Item Name: Crosstube Turning Detail

DART AEROSPACE LTD	Work Order:	82575
Description: Crosstube Assembly (205/212/412 High Fwd)	Part Number:	D212-664-141
Inspection Dwg: D212-664-141 Rev: D		Page 1 of 1

DRAWING NO. D212-664-141	TITLE XTUBE ASSY (205/212/412 HI FWD)	REV. D	DART AEROSPACE LTD ENGINEERING ORDER		D.E.O. NO. D212-664-141-D-1	SHEET NO. SHEET 1 OF 2	SCALE NTS
DRAWN	CHECKED	MFG. APPR.	APPROVED	DE APPR.			
DATE 11.04.07	DATE 11.04.11	DATE 11.04.12	DATE 11/04/12	DATE 11.04.12

DRAWING NO. D212-664-141	TITLE CROSSTUBE ASS'Y (205 HI FWD)	REV. D	DART AEROSPACE LTD ENGINEERING ORDER		D.E.O. NO. D212-664-141-D-2	SHEET NO. SHEET 1 OF 1	SCALE NTS
DRAWN <i>UP</i>	CHECKED <i>ASS</i>	MFG. APPR. <i>AS</i>	APPROVED <i>MD</i>	DE APPR. <i>HT</i>			
DATE 11.07.15	DATE 11.07.20	DATE 11.07.21	DATE 11/07/21	DATE 11.07.21

**D212-664-141/-141B
ASSEMBLY DETAIL**

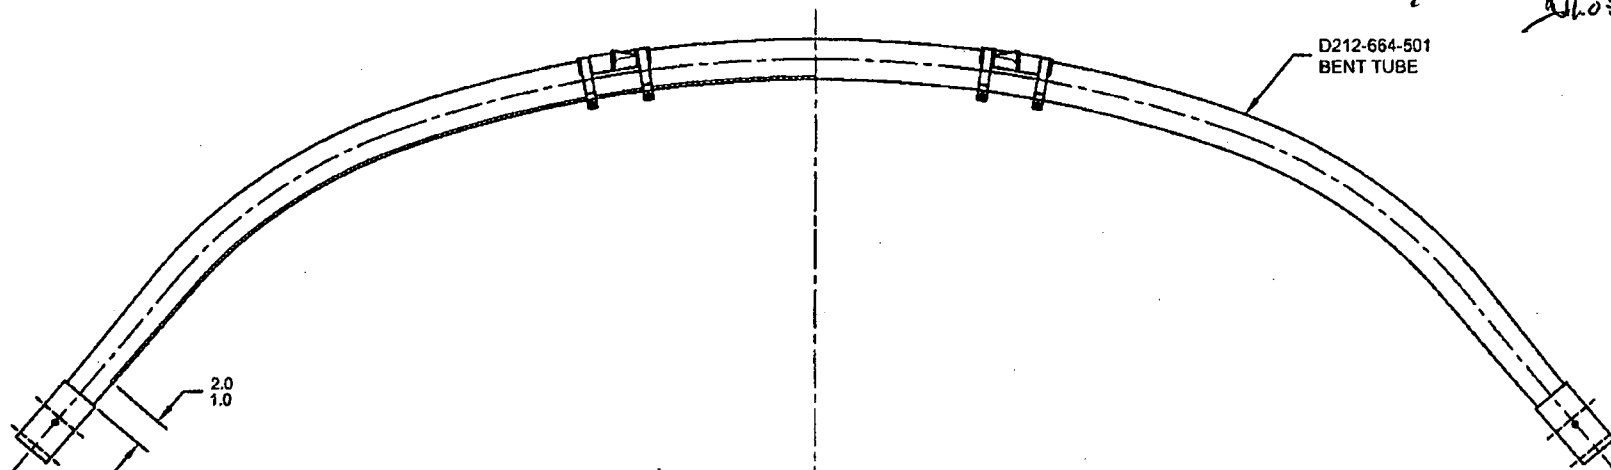
PURPOSE:

ADD AN INSPECTION WINDOW TO UNDERSIDE OF CROSSTUBE.

NOTES 2 OF SHEET 1 IS AMENDED AS FOLLOWS:

- 2) FINISH: CHEMICAL CONVERSION COAT PER DART QSI 005 4.1
PRIME INSIDE AND OUTSIDE PER DART QSI 005 4.2
MASK UNDERSIDE OF CROSSTUBE AS SHOWN (HATCHED AREA) AND
PAINT OUTSIDE PER DART QSI 005 4.2
REMOVE MASKING AND APPLY CLEAR COAT

MASK AREA PRIOR TO PAINTING,
REMOVE MASKING AFTER PAINT
AND APPLY CLEAR COAT

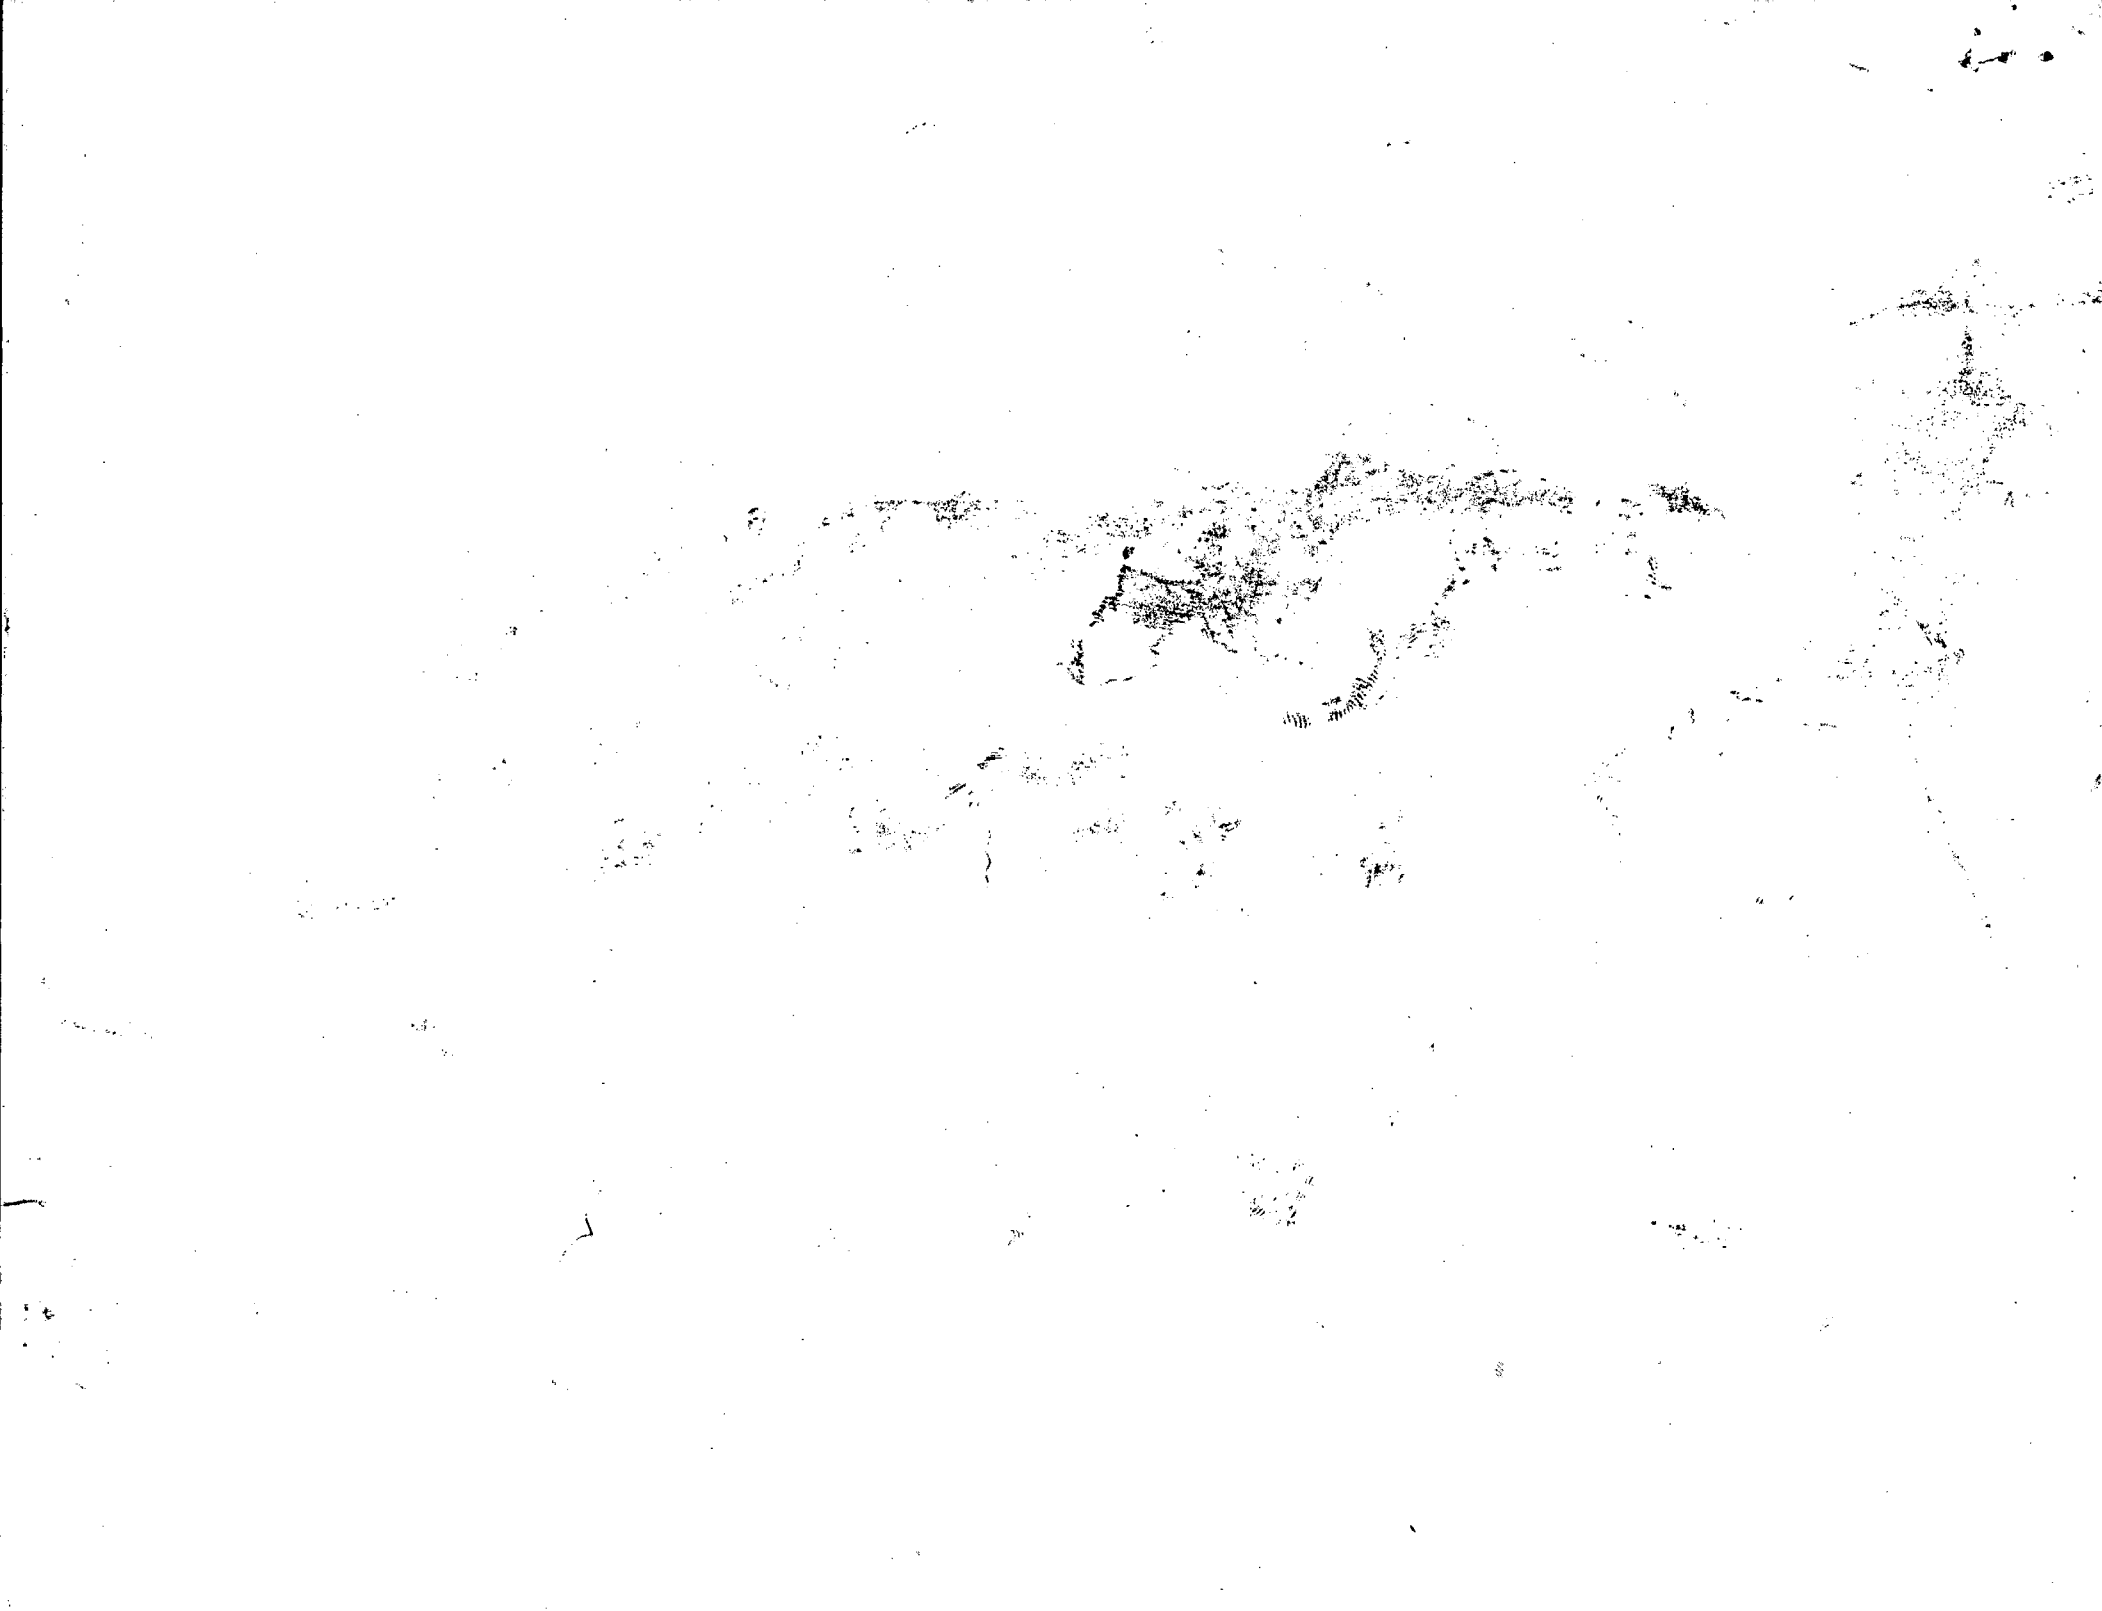
REPLACE MAGNOBOND WITH PROSEAL.

NOTE 12 & 15, SHEET 1 IS AMENDED AS FOLLOWS:

Item	Qty -141	Qty -141B	Part Number	Description
7	A/R	A/R	PROSEAL 890 B-2	SEALANT, AMS-S-8802 CLASS B-2

- 12) TO INSTALL D2893-1 SUPPORT: ABRASE MATING SURFACE OF SUPPORT AND CROSSTUBE WITH 180-GRIT SANDPAPER AND REMOVE RESIDUE WITH MEK (OR EQUIVALENT). APPLY A 0.04" TO 0.07" THICK LAYER OF PROSEAL 890 CLASS B-2 (OR AMS-S-8802 CLASS B-2) SEALANT TO MATING SURFACE OF SUPPORT.
- 15) TORQUE CLAMPS 80 TO 100 IN-LB. ENSURE AT LEAST 1.5 THREADS SHOWING IN SAFETY AND THAT NUT HAS NOT BOTTOMED-OUT AFTER TORQUING. **PRIOR TO PACKAGING, RE-CHECK TORQUE ON CLAMPS AFTER PROSEAL 890 SEALANT HAS CURED FOR 72 HOURS.**
